SERVICE BULLETIN
OPTIONAL**N° 139-581****DATE:** March 25, 2021**REV. :** A - February 1, 2024

TITLE**ATA 21 - VENTILATION INSULATION IMPROVEMENT****REVISION LOG**

This Service Bulletin is issued in order to provide the necessary instructions on how to perform the installation of ventilation improvement insulation P/N 3G2140P00811.

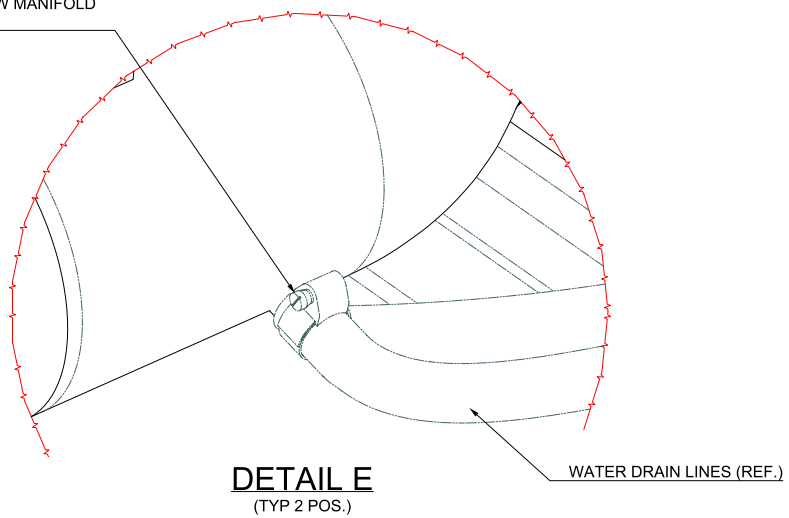
SEAL WITH:
MC-780 B SEALANT
(ALL AROUND THE AIR VENT DUCT ASSY PERIMETER)

REMOVE AND INSTALL ON THE NEW MANIFOLD
(USING EXISTING FASTENERS)

- 2.22 With reference to Figure 2, remove gasper duct assy P/N 3G21106P01331.
- 2.23 With reference to Figure 3 and Figure 4 Detail F, install manifold P/N AA0725A-00 using existing hardware and one strap P/N AW001CK06HS.

- 2.24 With reference to Figure 3 Detail E, reinstall the n°2 water drain lines using existing fasteners.

Seal all around the air vent duct assy perimeter with a fillet of sealant MC-780 B, as shown on Figure 4 Detail D.

DETAIL J
(TYP 4 POS.)

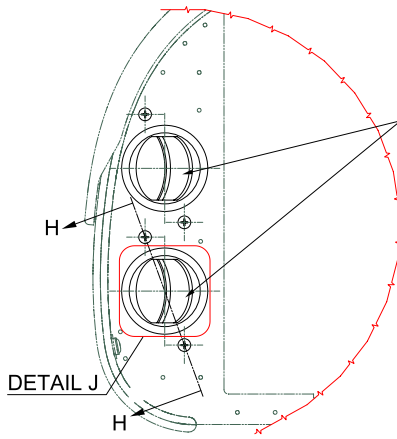
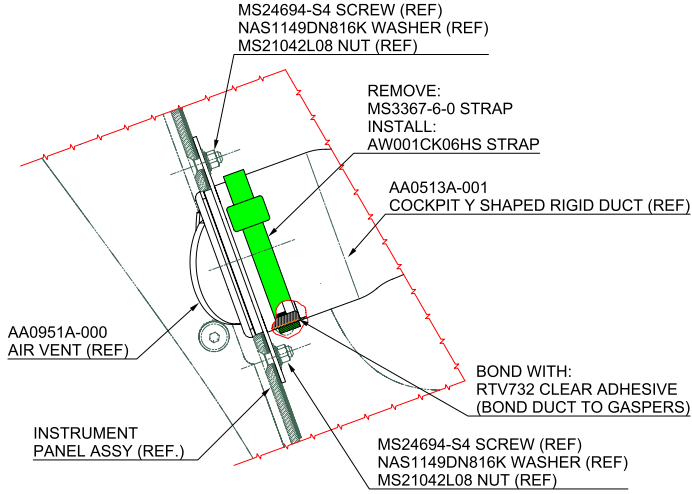
- 2.47 In accordance to applicable maintenance steps of AMP DM 39-A-21-20-06-00A-720A-A install top left air vent P/N AA0951A-000 using existing hardware. After the air vent assembly, apply 2 drops of Loctite 406 on the ventilation outlet in the 2 positions as shown on Figure 5 Detail J.

- 2.50 In accordance to applicable maintenance steps of AMP DM 39-A-21-20-07-00A-720A-A install bottom left air vent P/N AA0951A-000 using existing hardware. After the air vent assembly, apply 2 drops of Loctite 406 on the ventilation outlet in the 2 positions as shown on Figure 5 Detail J.

- 1 - AFTER THE AIR VENT ASSEMBLY, APPLY 2 DROPS OF LOCTITE 406 ON THE VENTILATION OUTLET IN THE 2 POSITIONS SHOWN ON "DETAIL J".
- 2 - DURING THE APPLICATION OF LOCTITE 406 BE CAREFUL TO NOT APPLY THE SEAL ON THIS PART.

SECTION H-H
(TYP 4 POS.)

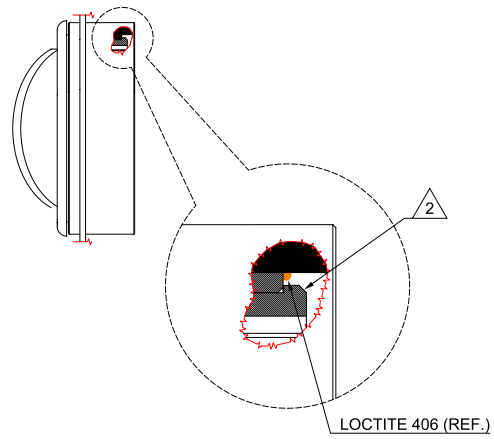
- 2.48 With reference to Figure 5 Section H-H, install cockpit Y shaped rigid duct on top left air vent P/N AA0951A-000 using adhesive RTV732 and strap P/N AW001CK06HS.

- 2.51 With reference to Figure 5 Section H-H, install cockpit Y shaped rigid duct on left bottom air vent P/N AA0951A-000 using adhesive RTV732 and strap P/N AW001CK06HS.

REMOVE:
AA0934A-000 AIR VENT (2 POS.)
MS24694-S4 SCREW (4 POS.)
NAS1149DN816K WASHER (4 POS.)
MS21042L08 NUT (4 POS.)
INSTALL:
AA0951A-000 AIR VENT (2 POS.)
MS24694-S4 SCREW (4 POS.)
NAS1149DN816K WASHER (4 POS.)
MS21042L08 NUT (4 POS.)
(REUSE EXISTING FASTENERS)

Figure 6

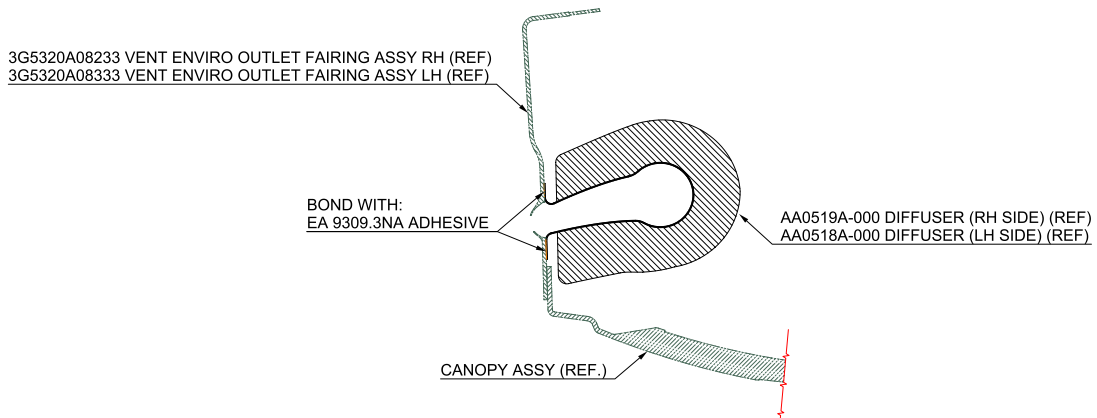
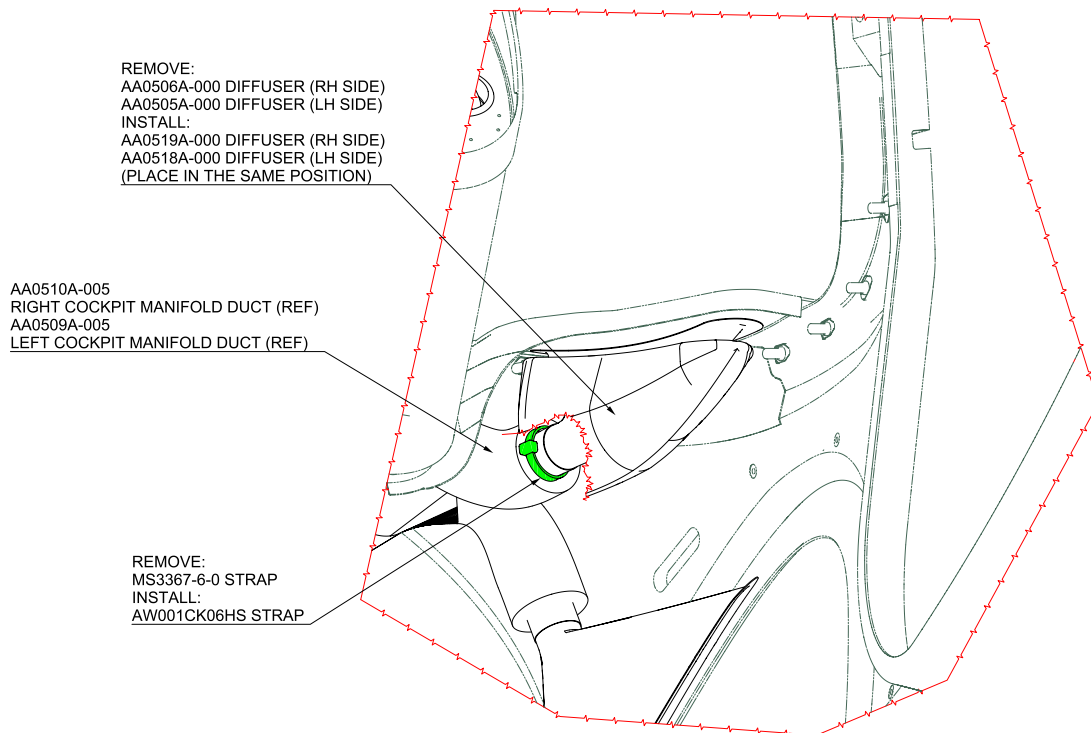
- 2.41 In accordance to AMP DM 39-A-71-11-07-00A-720A-A install forward sliding fairing 473AL.
- 2.42 With reference to Figure 6 View K, remove diffuser P/N AA0506A-000 (RH side), one strap P/N MS3367-6-0.

- 2.43 With reference to Figure 6 View K, install diffuser P/N AA0519A-000 (RH side), one strap P/N AW001CK06HS.
- 2.44 With reference to Figure 5 View L, Figure 6 Section M-M, bond diffuser P/N AA0519A-000 on ventilation environmental outlet fairing assy RH P/N 3G5320A082333 using adhesive EA9303.3NA.
